**2019 CMOM PACKAGE 2 (URGENT)**

**Solicitation Number: CO-00333**

**Job No.: 19-4533**

**ADDENDUM 2**

**REVISIONS**  
2019 CMOM PACKAGE 2 (URGENT)  
**SHASTA AVE. SAN. SEWER LAYOUT SHEET 1 OF 1**

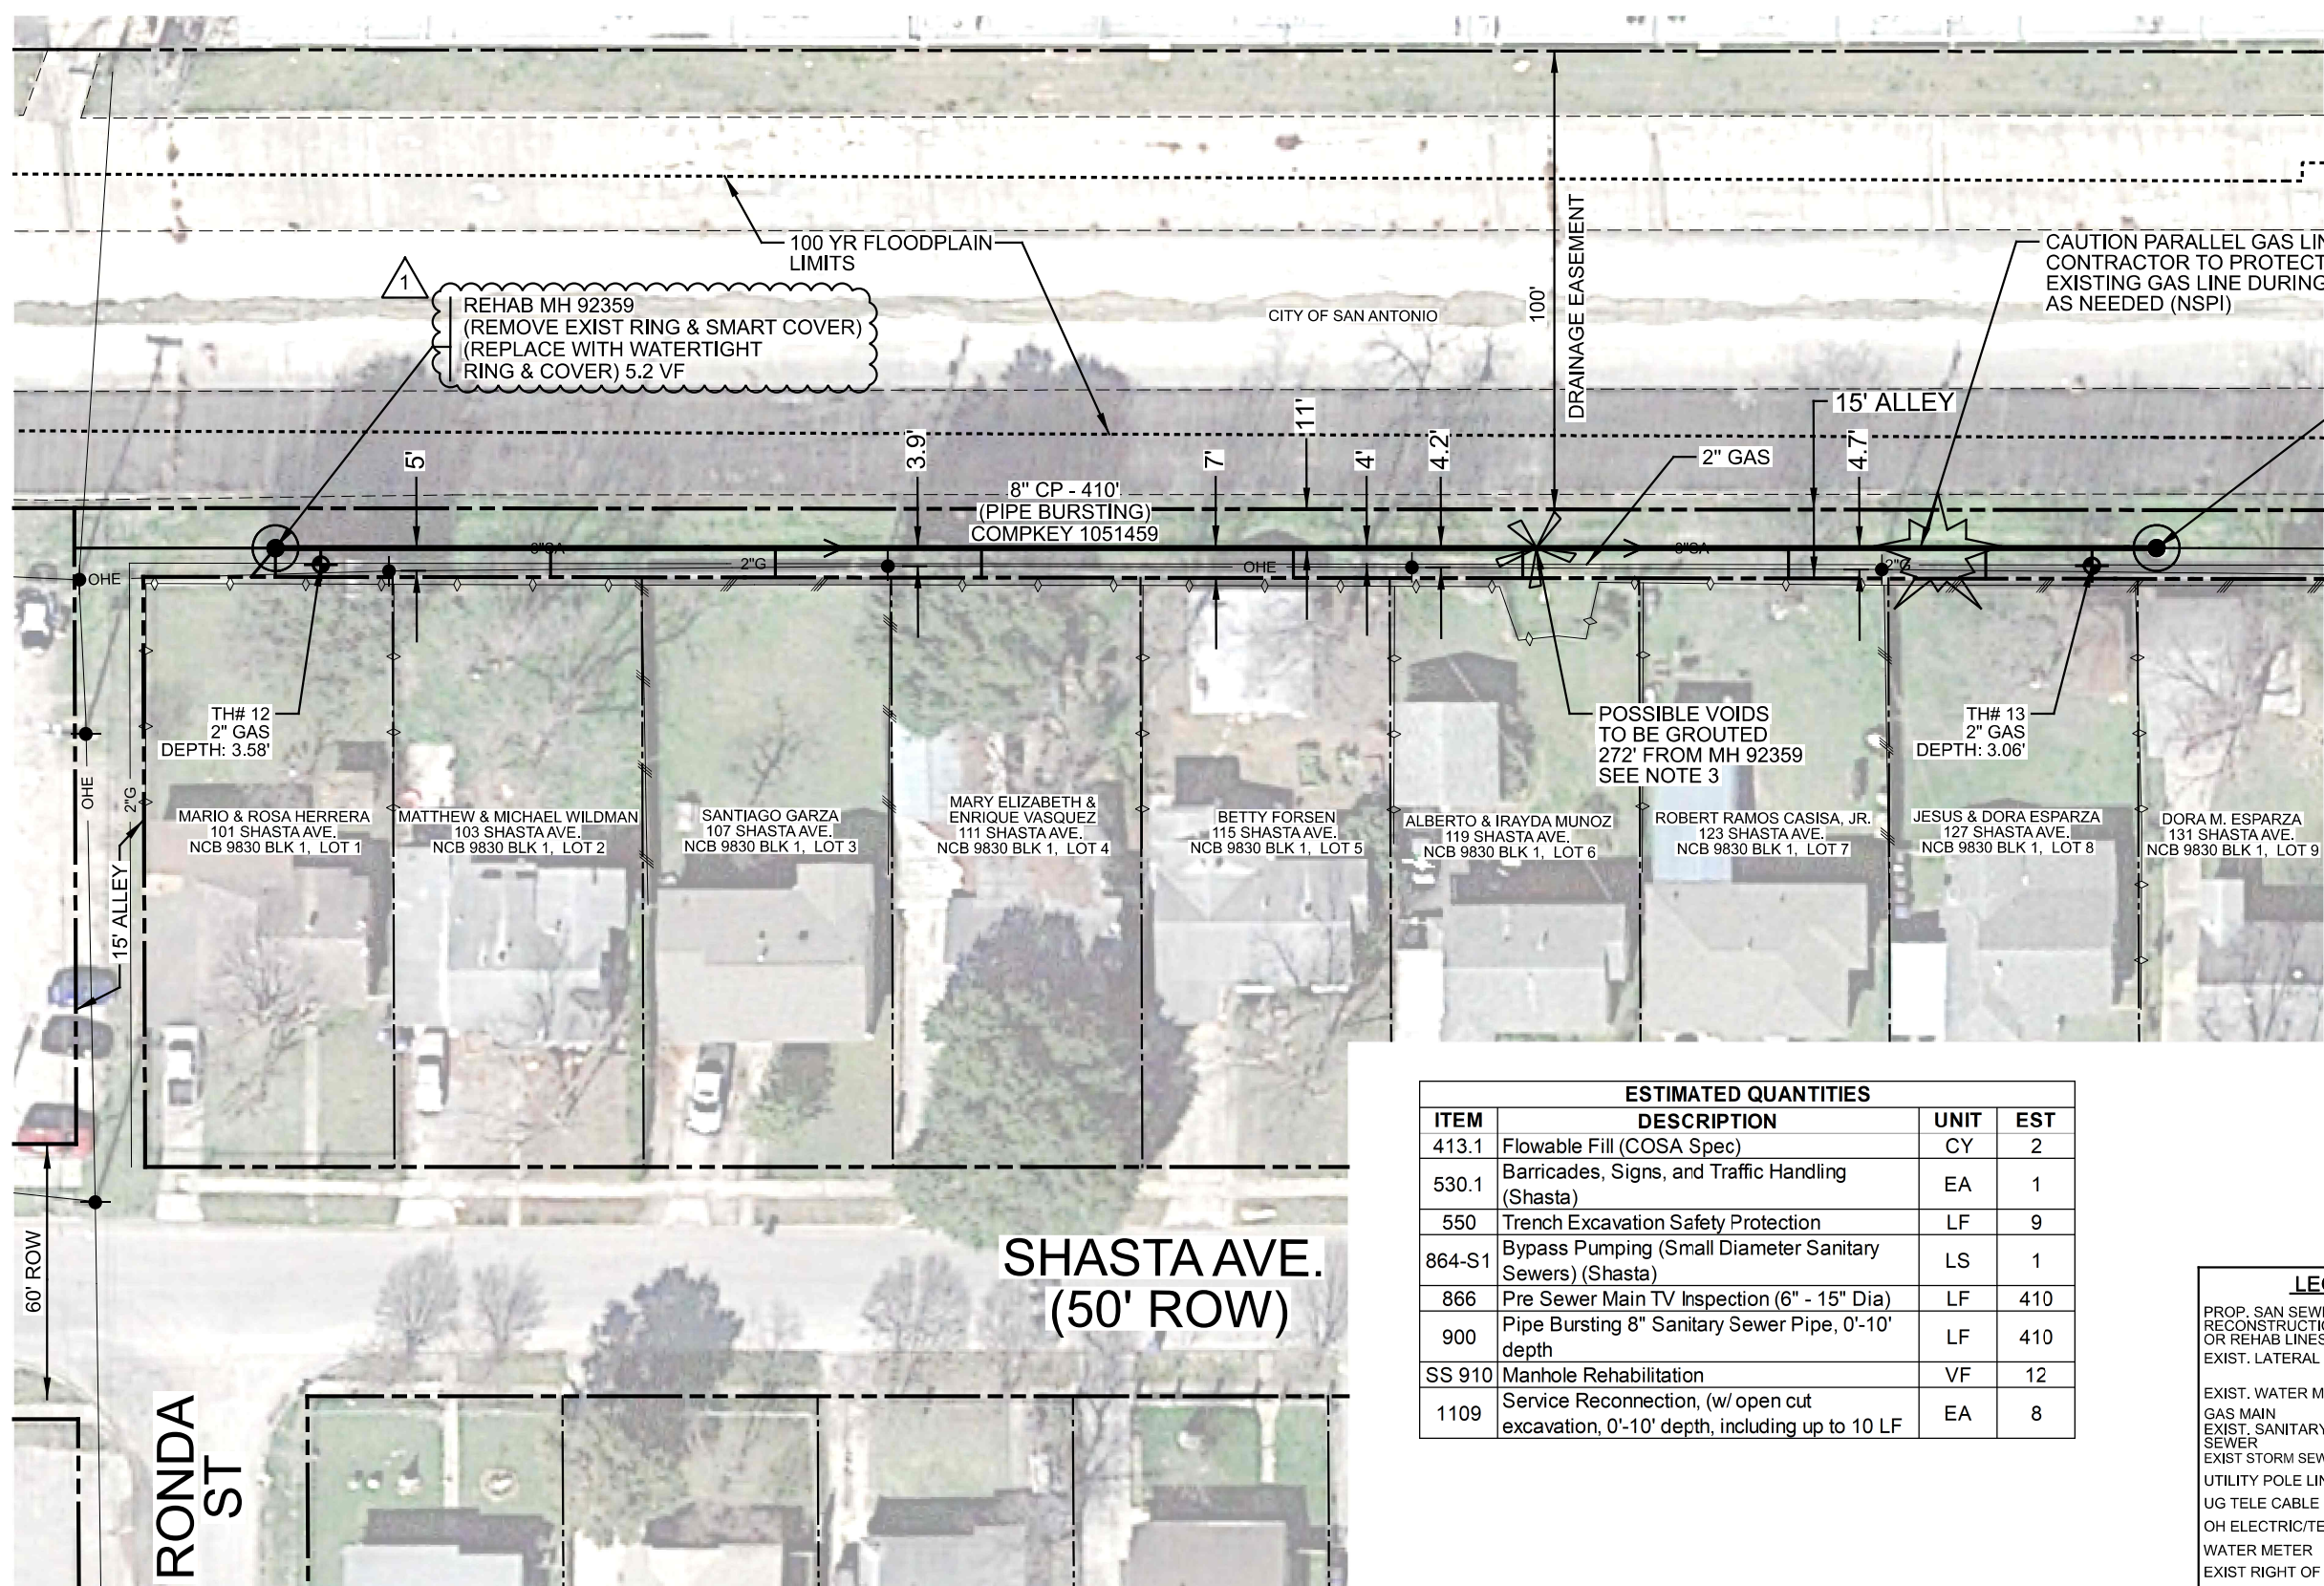
- 8. Sheet 16: Remove and replace with the attached sheet within this Addendum. ADJUST MH callout has been **removed**. Remove and replace ring and cover to be paid for under SS910 Manhole Rehabilitation.
- 9. Sheet 20: Remove and replace with the attached sheet within this Addendum. The following note was **added**: CONTRACTOR SHALL NOT PERFORM WORK DURING RAIN EVENTS. THE BYPASS SYSTEM SHALL NOT OBSTRUCT STORM RUNOFF FROM ENTERING THE SIDEWALK BRIDGE TO THE FLUME OR OBSTRUCT FLOW WITHIN THE DRAINAGE FLUME.
- 10. Sheet 21: Remove and replace with the attached sheet within this Addendum. The following note was **added**:
  - 1. CONTRACTOR SHALL NOT BURY BYPASS PIPING UNDER DRIVEWAYS ON NOGALITOS ST.
